# DEFENSE NUCLEAR FACILITIES SAFETY BOARD

August 1, 2003

## Staff Issue Report

**SUBJECT:** Aqueous Processing of Scrap Plutonium-238 Oxide at Los Alamos National Laboratory

**Figure 2. Dissolution Filtrate Storage Vessel (Los Alamos National Laboratory, 2002b)**

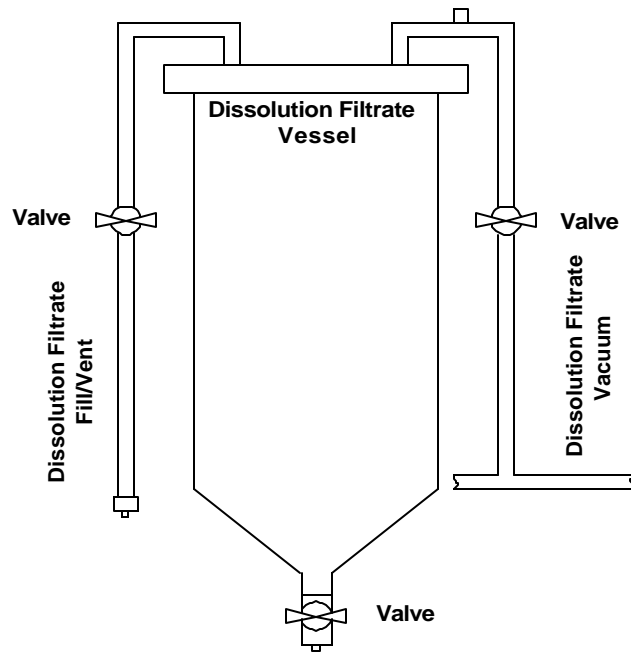
In addition, solutions transferred from the dissolver to the filtrate storage vessels will continue to generate hydrogen at the same rate. The LFL will be reached in the filtrate storage vessels within 6 hours, assuming an unvented 7 liter headspace. The stoichiometric concentration for hydrogen and oxygen will be reached in the storage vessel in less than 2.5 days.

*Filtrate Storage Vessel Safety Controls*—Neither the PrHA nor the SER analyzes a deflagration in a filtrate storage vessel or identifies functionally classified safety controls to prevent such an event. In response to comments from NNSA on hydrogen generation, LANL states that small amounts of hydrogen will be generated in the storage vessel (Los Alamos National Laboratory, 2003d); as stated above, the staff's analysis shows that the LFL could be reached in less than 6 hours. There are two vessels, and each has a level sensor and pressure relief valve. The pressure relief valve is not functionally classified as a safety control and should not be relied upon to preserve the vessel's integrity in the event of a hydrogen deflagration. The storage vessels do have vent lines, but there are no safety controls identified to ensure that the vent lines are open. Also, the U-shaped configuration of the vent lines will hinder the buoyant migration of hydrogen (see Figure 2). Diffusion of hydrogen will occur through the line, but no analysis has been performed to show that the equilibrium hydrogen concentration in the vessel will remain below the LFL. Since filtrate may be stored for extended periods of time, the possibility exists for flammable amounts of hydrogen to accumulate in the filtrate storage vessel. The opportunity for an ignition source in the filtrate storage vessel is less than that in the dissolver vessel, but a conservative hazard analysis should always assume the presence of an ignition source. A safety control to either vent or purge the vessel would address this accident scenario.

Figure 3. Resin Color as a Function of Alpha Dose (Marsh, 1991)

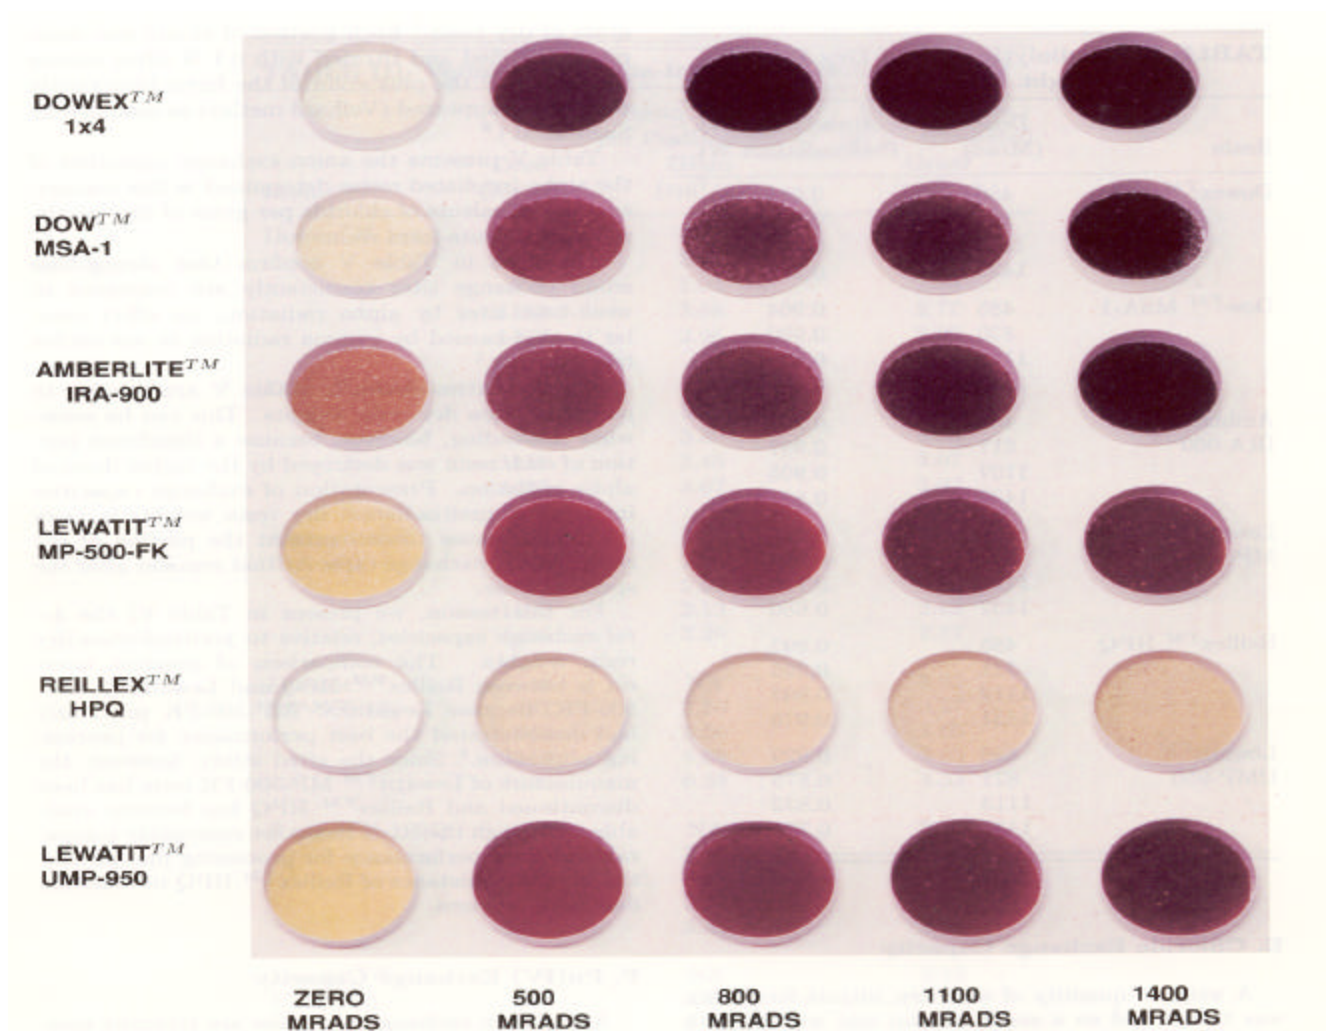
The revised PrHA proposes surveillance of resin exposure in addition to annual resin replacement, but the PrHA and the SER do not explain how this surveillance will be performed. Furthermore, the December 2000 SER imposed what was intended to be a safety factor of two for the resin lifetime. The newly proposed controls accept a reduced safety factor. This reduction in the safety factor, combined with a potentially nonconservative estimation of resin dose, could result in an unsafe resin condition.

**Figure 4. Maximum Resin Temperature for Loss of Flow, Maximum Concentration, and Double Loading (Laurinat, J. E. and M. E. Pansoy-Hjevnik, 1999)**

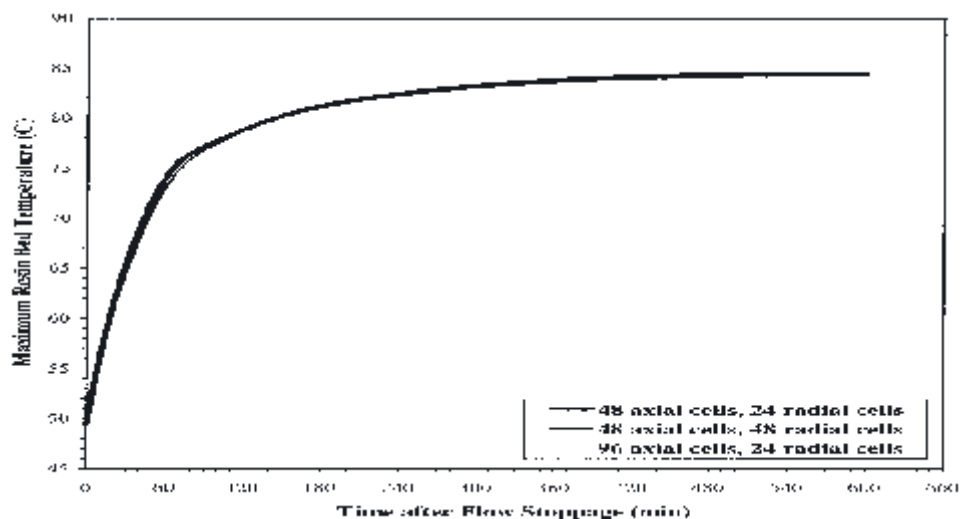
*Thermal Analysis*—The May 2003 PrHA states that the resin temperature can reach a maximum of 50°C. A thermal analysis was performed by Westinghouse Savannah River Company to determine the maximum temperatures of the ion exchange column (Laurinat and Panson-Hjevick, 1999). The analysis demonstrated that the column temperature would remain below 50°C under normal operating conditions. However, the calculation concluded that the column could reach approximately 84°C under abnormal conditions (see Table 1 and Figure 4). This scenario assumes that the resin has been loaded with twice the normal quantity of Pu-238 and that there is no flow of solution through the column. High column temperatures would degrade the resin, leading to further heat evolution. The column could eventually dry out or pressurize from evaporated water. Moreover, if the column heated to such a temperature, self-heating of the resin could initiate, as shown by the bomb calorimeter testing discussed below.

The staff believes the abnormal conditions that could lead to self-heating of the resin are credible. The pumps that provide solution flow through the columns are not functionally classified, and their reliability was not considered in the hazard analysis. Furthermore, although loading two batches of Pu-238 on the resin columns is not allowed in the operating procedure (Los Alamos National Laboratory, 2002d), the resin is physically capable of holding significantly more than a double batch of Pu-238. Kyser (2000) has demonstrated that the 2 liter volume of the Reillex HPQ resin to be used in the column can adsorb 234 g of

**Figure 7. HAN/HNO<sub>3</sub> Instability as a Function of Temperature (U.S. Department of Energy, 1998)**

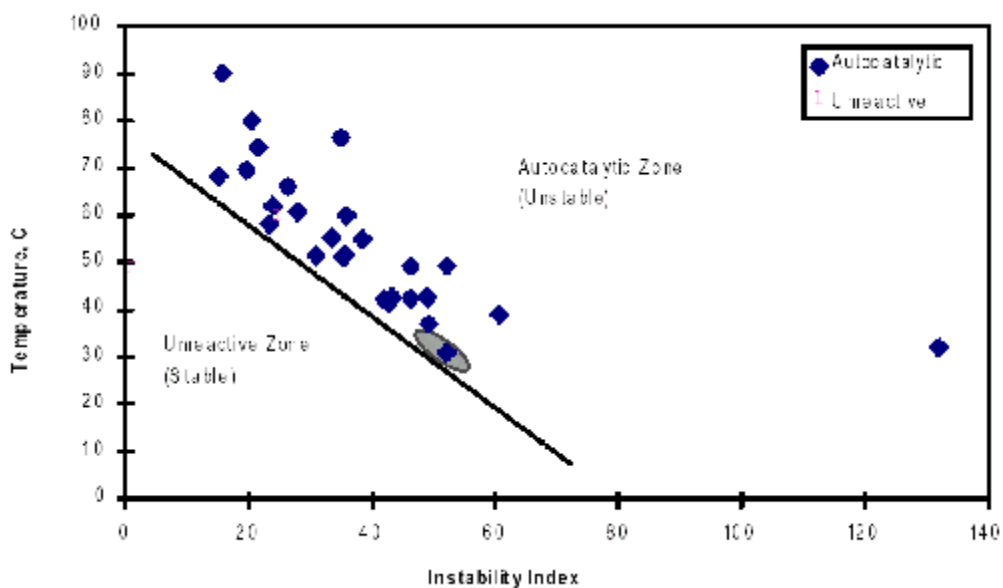
The HAN used in the recovery line is 2.8 M. DOE's technical report suggests that HAN concentrations below 2–3 M lack the necessary energy density to generate high pressures or explosive reactions. Therefore, the 2.8 M HAN solution used by LANL appears to be in an intermediate range with respect to energy density. At a HAN concentration of 2.8 M, the heat of reaction may vaporize enough water to concentrate the HAN and thus increase its energy density to an unsafe regime.

The March 2000 PrHA did address reactivity hazards of HAN, but identified no functionally classified controls. The Board's April 2002 letter stated that LANL had yet to demonstrate how the recommendations provided in DOE's technical report on HAN had been implemented in the recovery line, as required by NNSA's December 2000 SER. The January 2003 and May 2003 PrHAs reanalyze the consequences of a HAN/nitric acid reaction and propose dual independent administrative verifications of acid concentration to prevent undesirable reactions. This control is not captured as a TSR. Given the numerous other administrative controls, it is not clear to the Board's staff that the verification of acid concentration will be implemented with a rigor commensurate with its importance to worker safety. The report of a LANL readiness review of the aqueous recovery line performed in July 2002 concluded that overuse of second-person verifications limits their effectiveness (Los Alamos National Laboratory, 2002e). The staff believes verification of acid molarity would be implemented with greater certainty if specified as a TSR.
